Validation report form for post-registration changes for CDM project activities
(Version 01.0)

VALIDATION REPORT ON POST-REGISTRATION CHANGES (PRCs)

Title and reference number of the project activity	75MW Yunnan Nuozu Hydropower Project
Process track	<input type="checkbox"/> Prior approval <input checked="" type="checkbox"/> Issuance <input type="checkbox"/> Renewal of crediting period
Version number of the validation report on PRCs	Version 01
Completion date of the validation report on PRCs	08/02/2017
Type(s) of PRCs	<input type="checkbox"/> Temporary deviations from the registered monitoring plan, monitoring methodology or standardized baseline <input type="checkbox"/> Corrections <input type="checkbox"/> Changes to the start date of the crediting period <input type="checkbox"/> Inclusion of a monitoring plan to a registered project activity <input checked="" type="checkbox"/> Permanent changes from registered monitoring plan, monitoring methodology or standardized baseline <input type="checkbox"/> Changes to the project design of a registered project activity <input type="checkbox"/> Types of changes specific to afforestation and reforestation project activities

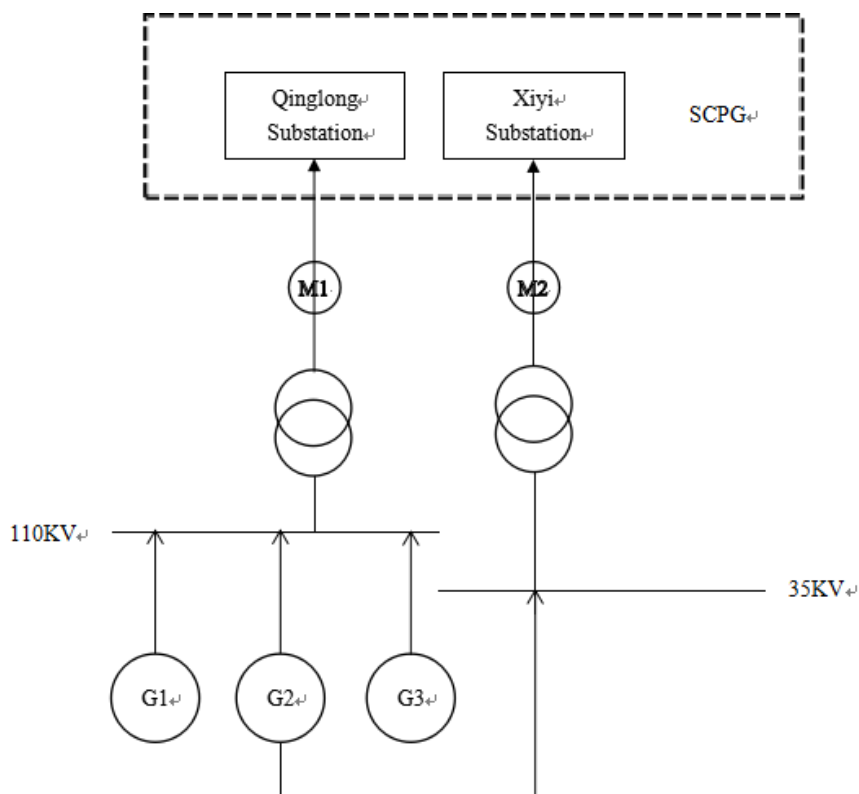
By reviewing the revised PDD version 03.0 /2/ and the registered PDD Version 02.0 /3/, the permanent changes from registered monitoring plan are summarized as: according to the PPA signed with the power grid /7/, the electricity generated by the project activity is connected via one 110KV line to Qinglong substation and one 35KV line to Xiyi substation, which is different from the two 110KV lines connected with Qinglong substation and Xiyi substation in the registered PDD. Furthermore, the location of the two main meters (M1 and M2) has been changed from the high voltage side of the transformer in the project site to Qinglong substation and Xiyi substation.

Based on the onsite inspection, the verification team can confirm that the generated electricity is exported to SCPG via the 110KV line and one bidirectional electricity meters (M1) with accuracy class of 0.2S was installed at Qinglong substation, and the 35KV transmission line is still not finished. The meter installed at Qinglong substation (M1) measure both the electricity delivered to SCPG ($EG_{out,y}$) and the electricity imported from SCPG ($EG_{in,y}$). The meter installed at Xiyi substation (M2) will be applied after the 35KV transmission line connects to SCPG.

Please refer to the below diagram for an overview on how the project activity is connected to the grid, and the location of the electricity meters as described above.

Findings	No findings raised in this section.
Conclusion	<p>The validation team confirms:</p> <ul style="list-style-type: none"> ✓ The permanent changes to the registered monitoring plan described in the revised PDD /2/ are in compliance with the applied methodology /5/; ✓ The permanent changes from the registered monitoring plan do not reduce the level of accuracy of the monitoring compared with the requirements contained in the registered monitoring plan, and are unlikely to lead to a reduction in the accuracy of the calculation of emission reductions; ✓ The permanent change to the monitoring plan is of a type described in the Project Standard Appendix 1 /1/ that does not need prior approval.
